Re: Initial Submission Review: Green Valley Ranch East – Site Plan No. 19, Plat Vacation and Plat
Application Number: DA-1662-35
Case Number: 2021-4010-01; 2021-3017-01; 2024-3030-00

On behalf of Oakwood Homes and Terracina Design, we have reviewed the initial submission comments dated July 16, 2024. The following is a response to comments.

**GREEN VALLEY RANCH EAST
SITE PLAN #19 W/ ADJUSTMENTS**

I- DUPLEX ALLEY-LOADED HOME (MID BLOCK LOTS)

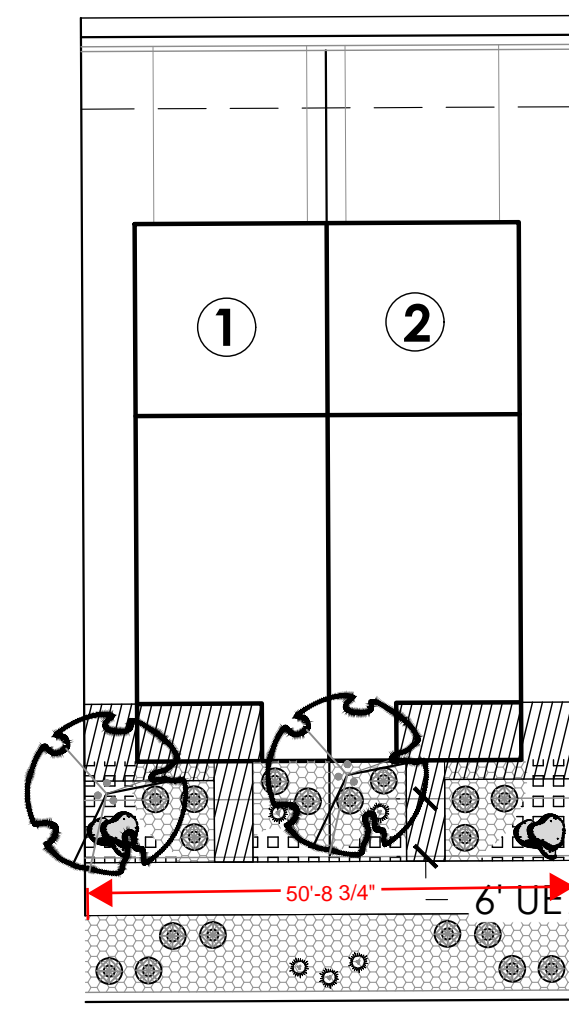
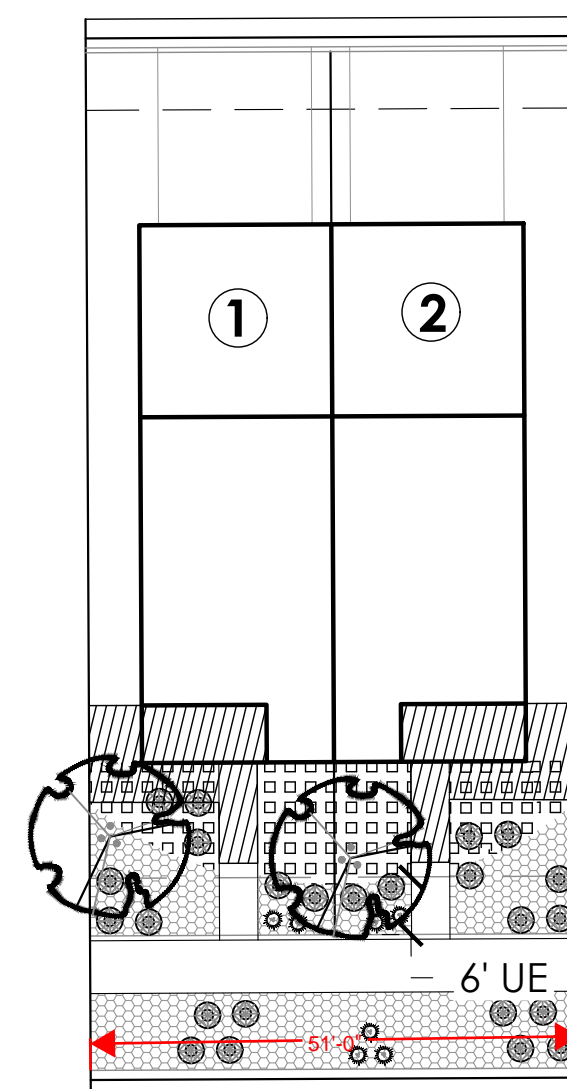
Lots 67, 68 and 69, Block 2 are significantly wider than other 1 lots. Provide separate typicals.

TYPICALS ADDED.
